SIB 61 16 17

## CHARGING SOCKET EMERGENCY RELEASE DAMAGED

2019-12-10

This Service Information Bulletin (Revision 2) replaces SI B61 16 17 **dated August 2018**.

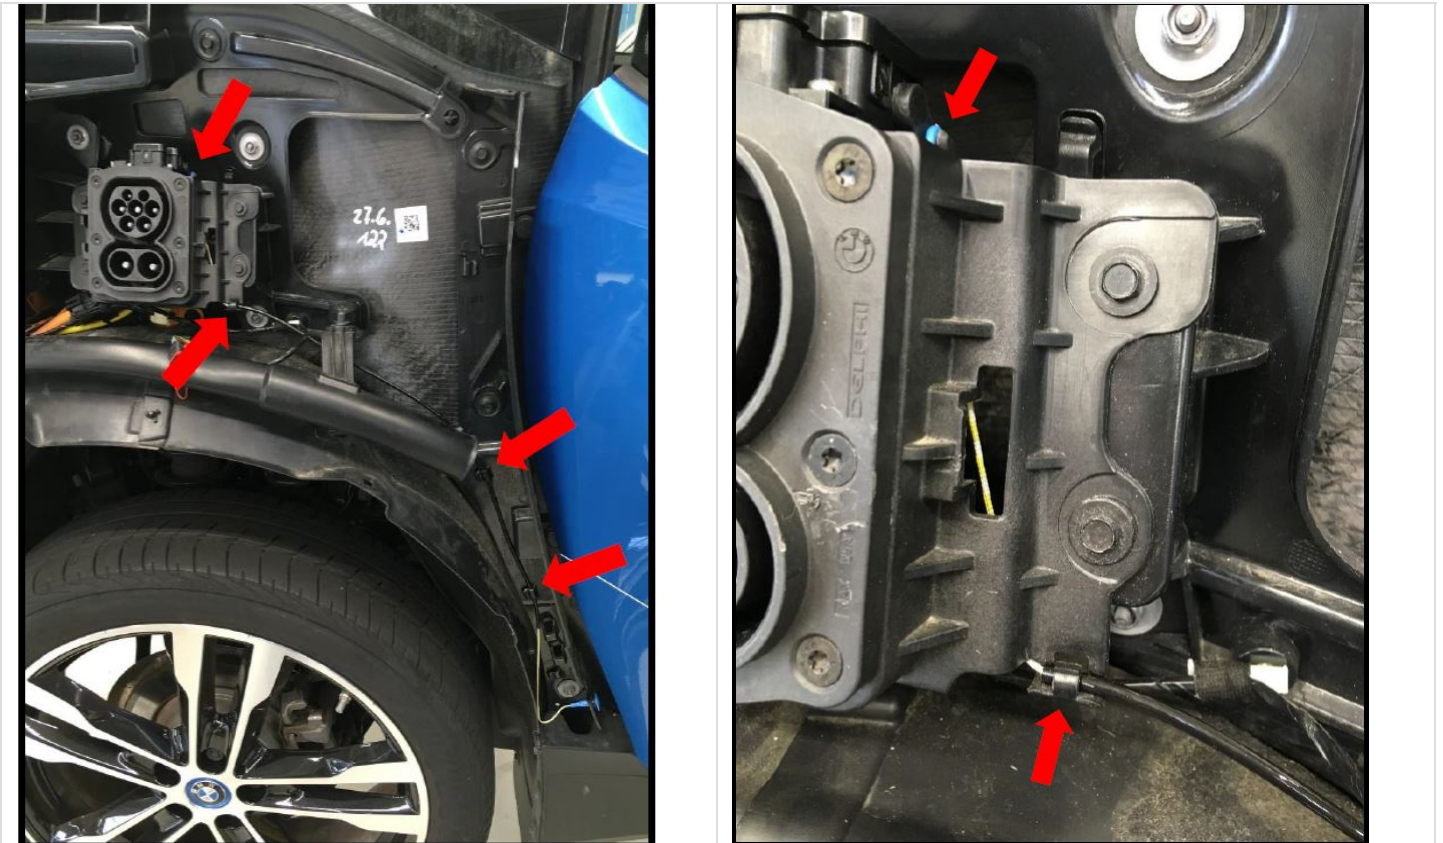
- Updated photo of correct cable routing

The replacement tensioning strap design has been improved to help the cable glide easier. Replace the original tensioning strap.

Note: During this process, install a new tensioning strap, routing as shown below (revised photos).
